Design Review Subcommittee (DRSC)

SUBJECT: Discretionary Sign Permit 17-347, Flora Vista Entry Sign, a request to allow project identification signs for Flora Vista Community with: 1) two new entry monument signs located at Calle Sarmentoso/Via Tulipan; Calle Sarmentoso/Via Solona; and, 2) two renovated entry wall signs located on both corners of Camino Del Rio and Via Tulipan.

DSP 17-347

Exhibit 2: Proposed Flora Vista Monument Signs

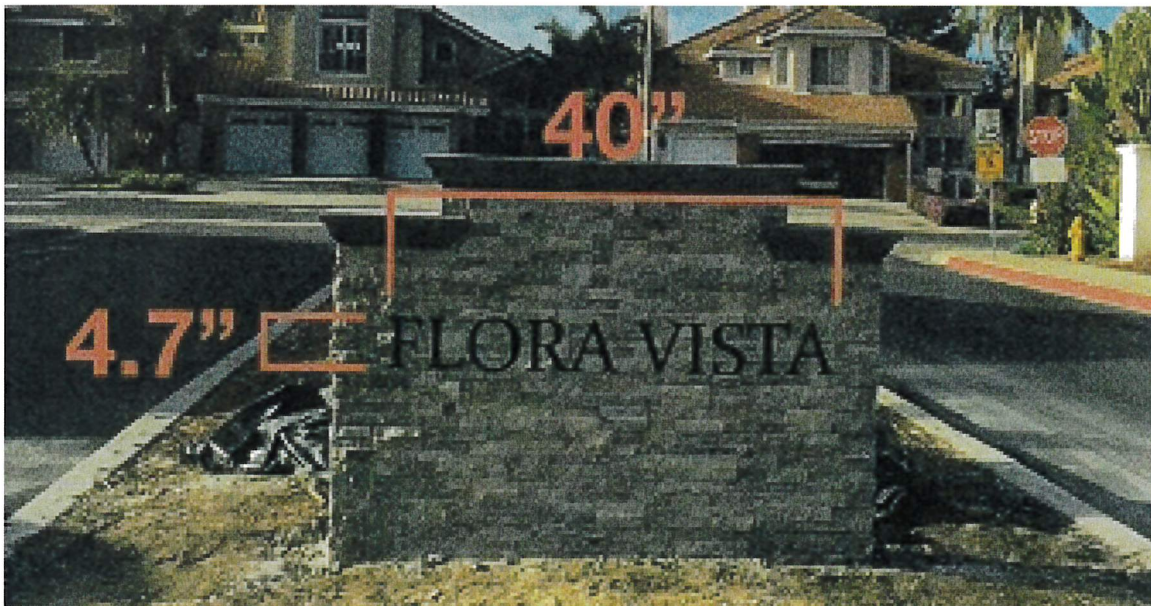
| | <i>Maximum Allowed</i> | <i>Proposed</i> | <i>Complies with Standard</i> |
|---------------------------------|-------------------------------|---|--------------------------------------|
| Sign Area | 24 sq. ft. | 1.31 sq. ft. Monument signs 4.25 sq. ft. Garden Wall signs | Yes Yes |
| Sign Height | 6' | 4'-1" Monument Signs 5'-9" Garden Wall Signs | Yes Yes |

The signs are consistent with all applicable development standards and are designed with high quality materials. The design and scale of the signs is proportional to the space where they are proposed to be located. Staff has no recommended changes but seeks DRSC comments on the project’s sign design. Staff recommends this project be forwarded to Planning Commission.
